Project	IEEE 802.16 Broadband Wireless Access Working Group < http://ieee802.org/16 >
Title	Amendment to Location Update Primitives in 14.2.4.3
Date Submitted	2007-03-1308
Source(s)	JeeHyeon Na, Jaesun Cha, Jung-Mo Moon and Sangho Lee jhna@etri.re.kr ETRI 161 Gajeong-dong, Yuseong-gu Daejeon 305-700 Korea
Re:	Contribution on comments to IEEE 802.16g/D8
Abstract	Re-definition of location update service primitives in section 14.2.4.3
Purpose	Adoption
Notice	This document has been prepared to assist IEEE 802.16. It is offered as a basis for discussion and is not binding on the contributing individual(s) or organization(s). The material in this document is subject to change in form and content after further study. The contributor(s) reserve(s) the right to add, amend or withdraw material contained herein.
Release	The contributor grants a free, irrevocable license to the IEEE to incorporate text contained in this contribution, and any modifications thereof, in the creation of an IEEE Standards publication; to copyright in the IEEE's name any IEEE Standards publication even though it may include portions of this contribution; and at the IEEE's sole discretion to permit others to reproduc

Figure 484 – Location Update Primitives

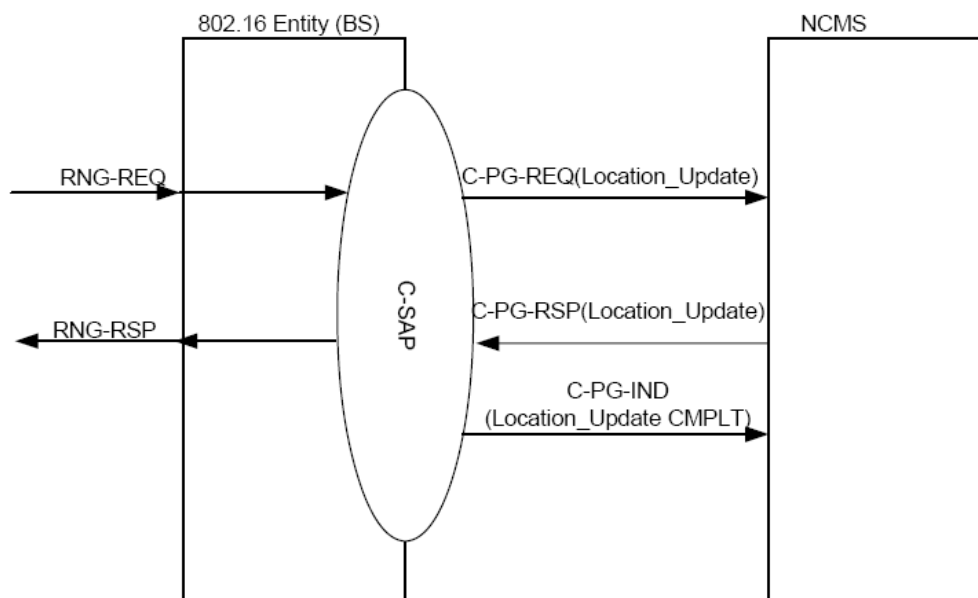
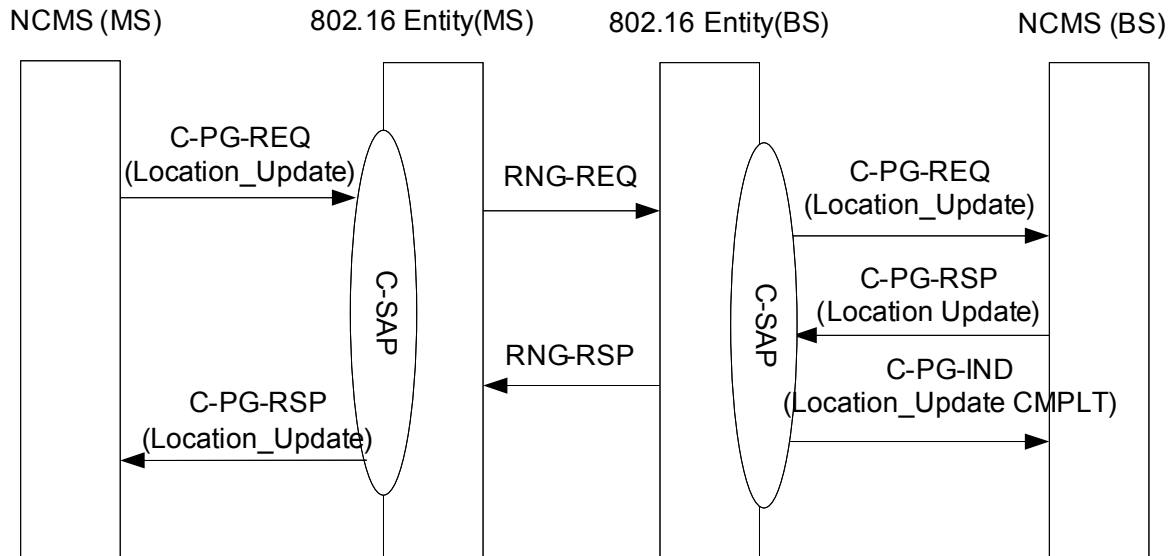
In current D8 document, there are only defined service primitives and figures between an 802.16 entity (BS) and an NCMS on the BS side in section 14.2.4.3, but not defined it between an 802.16 entity (MS) and an NCMS on the MS side.

However, the service primitives between an 802.16 entity (MS) and an NCMS on MS side are needed because an NCMS on MS side can generate location update service primitives to the MS.

Therefore, we modify the figure 484 and some related texts to be included service primitives between an 802.16 entity (MS) and an NCMS on MS side in this contribution.

Figure 484 shows service primitives for Location Update between an 802.16 entity ~~a BS~~ and the NCMS.
